**PLANNED UNIT DEVELOPMENT
& SUBDIVISION STAFF REPORT****Date: March 18, 2010**

<u>DEVELOPMENT NAME</u>	Oakland Avenue Subdivision, Cornell Addition
<u>SUBDIVISION NAME</u>	Oakland Avenue Subdivision, Cornell Addition
<u>LOCATION</u>	22 Oakland Avenue North side of Oakland Avenue, 430'± East of Marston Lane
<u>CITY COUNCIL DISTRICT</u>	District 7
<u>AREA OF PROPERTY</u>	4 Lots / 1.2 ± acres (Subdivision)
<u>CONTEMPLATED USE</u>	Planned Unit Development Approval to allow reduced lot sizes and reduced setbacks in an R-1, Single-Family Residential District, and Subdivision approval to create 4 lots.
<u>TIME SCHEDULE FOR DEVELOPMENT</u>	None given.
<u>ENGINEERING COMMENTS</u>	Detention will be required for Lots 2 and 3 due to the undersized receiving storm drainage system. Show the detention area on the plat and add a note to plat stating maintenance of detention system is to be the responsibilities of the property owners. Must comply with all storm water and flood control ordinances. Any work performed in the right of way will require a right of way permit.

APPLICATION NUMBER 13 & 14 DATE March 18, 2010

SITE PLAN

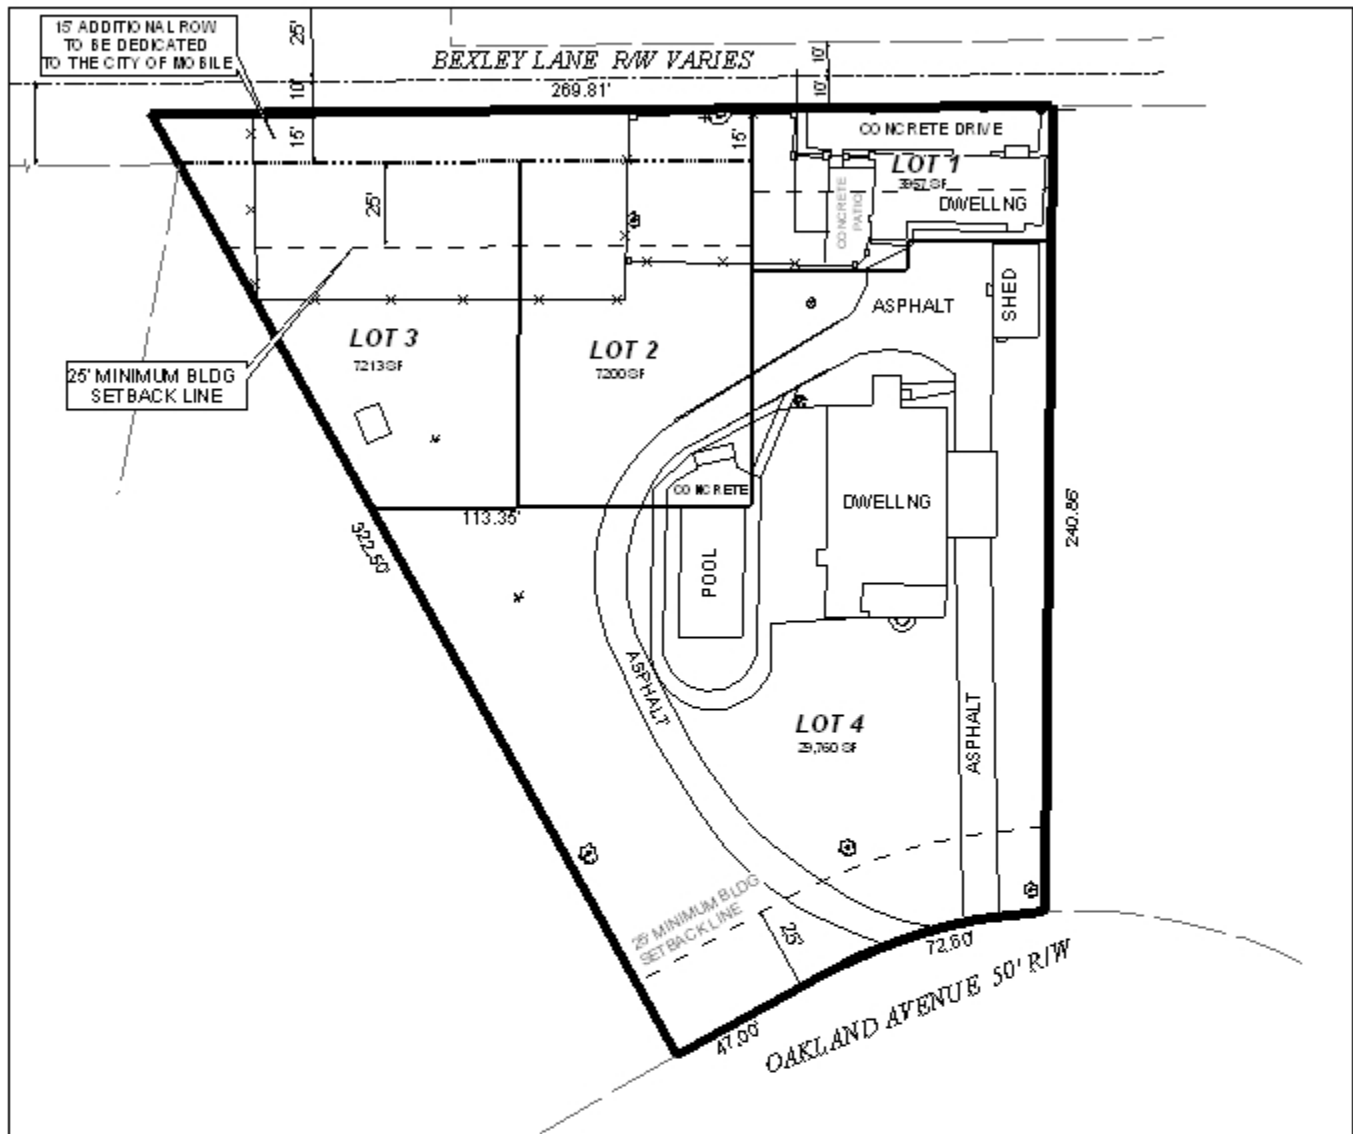
It should also be pointed out that the existing residence on Lot 1, and an existing shed on proposed Lot 4, will not comply with Zoning Ordinance required rear-yard setbacks from the proposed common lot line. An existing pool shed on proposed Lot 2 will not meet side yard setback requirements from a proposed lot line. The setback issues, along with the lot size issues, necessitate the PUD. When all lots are considered, there is more than adequate area for four lots, but the proposed lot lines to accommodate the existing conditions result in two lots falling below the minimum size requirements of the Subdivision Regulations. Staff believes that a PUD locking all proposed lots together may be sufficient to address lot size and setback requirements, however, the dimensions of proposed Lot 2 should be revised to ensure that it meets minimum lot size requirements. All new development must comply with standard setbacks for R-1 sites.

The PUD site plan should be revised to label the setbacks for the existing residence on Lot 1, and any existing sheds on any of the other proposed lots which are less than 8-feet from a lot line. Setback labeling is of critical importance for Lot 1, as it appears that a lot line is being placed less than 1 foot from the existing dwelling: the exact distance should be identified.

- 1) Revision of the site plan to ensure that Lot 2 is at least 7,200 square feet after any dedication;
- 2) Revision of the site plan to depict minimum setbacks for the existing dwelling on Lot 1 from the front, side and rear property lines;

- 3) Revision of the site plan to depict minimum setbacks for all other structures to remain on the site that are less than 8 feet from a lot line;
- 4) Placement of a note on the site plan stating that all new development must comply with R-1, Single-Family District setback requirements;

- 6) Dedication of right-of-way along Bexley Lane for Lots 2 and 3, as shown on the site plan;
- 7) Depiction of the minimum building setback line for Lots 2 and 3, as shown on the site plan;

- 8) Revision of the minimum building setback line for Lot 1 to match that depicted for Lots 2 and 3 (to allow for future dedication);
- 9) Revision of lot size information for all lots;

- 10) Placement of a note on the site plan stating that Lots 1 and 4 are limited to their two (2) existing curb-cuts each, that Lots 2 and 3 are limited to one (1) curb-cut each, and that size, design and location of any curb-cut must be approved by Traffic Engineering and be designed in conformance to the greatest extent possible with AASHTO standards;

SUBDIVISION DETAIL

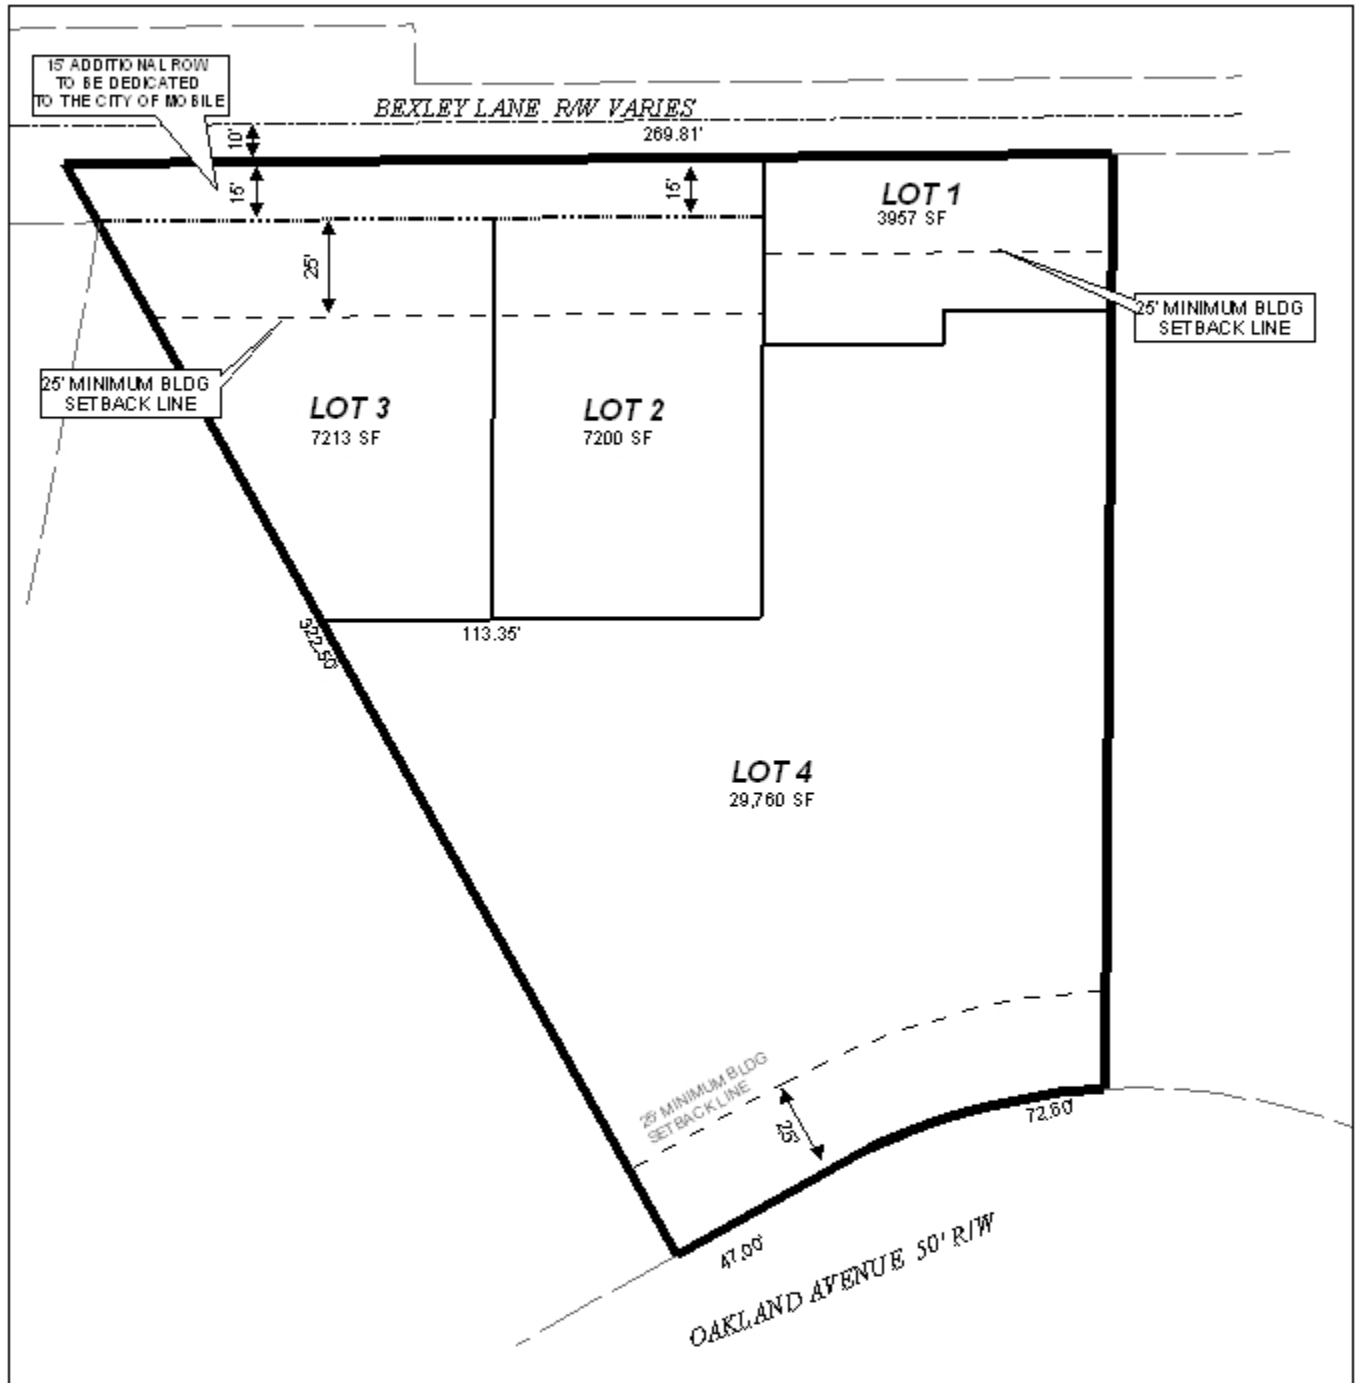
- 1) Compliance with Engineering comments (*Detention will be required for Lots 2 and 3 due to the undersized receiving storm drainage system. Show the detention area on the plat and add a note to plat stating maintenance of detention system is to be the responsibilities of the property owners. Must comply with all storm water and flood control ordinances. Any work performed in the right of way will require a right of way permit.*)

- 2) Revision of the dimensions of Lot 2 to ensure it is a minimum of 7,200 square feet after any dedication;
- 3) Correction of area calculations for all lots;

- 4) Dedication of right-of-way along Bexley Lane for Lots 2 and 3, as shown on the preliminary plat;
- 5) Depiction of the minimum building setback line for Lots 2 and 3, as shown on the preliminary plat;

- 6) Revision of the minimum building setback line for Lot 1 to match that depicted for Lots 2 and 3 (to allow for future dedication);
- 7) Placement of a note on the final plat stating that Lots 1 and 4 are limited to their two (2) existing curb-cuts each, that Lots 2 and 3 are limited to one (1) curb-cut each, and that size, design and location of any curb-cut must be approved by Traffic Engineering and be designed in conformance to the greatest extent possible with AASHTO standards;
